TITLE CT-1551 Contour Crimp Crimping Tool			
CUSTOMER DRAWING			
ITEM REVISION NAME R27603BA/02		PANDUIT	
DATASET FILE NAME R27603BA/02A_DS_TP27603B01			
DRAWN BY BLR		DRAWING NUMBER TP27603B01	
DATE 5-11-15	CHK BJPU	SCALE NONE	SHEET 1 OF 1
			SIZE B

Metal Injection Molded
Die Set, MIM (New)

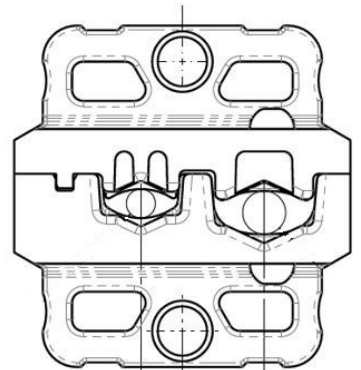
REV	DATE	BY	CHK	APR	DESCRIPTION	ECN
02A	7-28-2020	JEH	BJPU	BJPU	ADDED NOTE 10	080205/01
02	6-3-2020	JEH	BJPU	JADE	RECREATED THE CUST. DWG. IN NX. WAS A MS WORD DRAWING. ADDED DIE CHANGE NOTE 9 AND VIEWS (LOWER LEFT CORNER).	080905
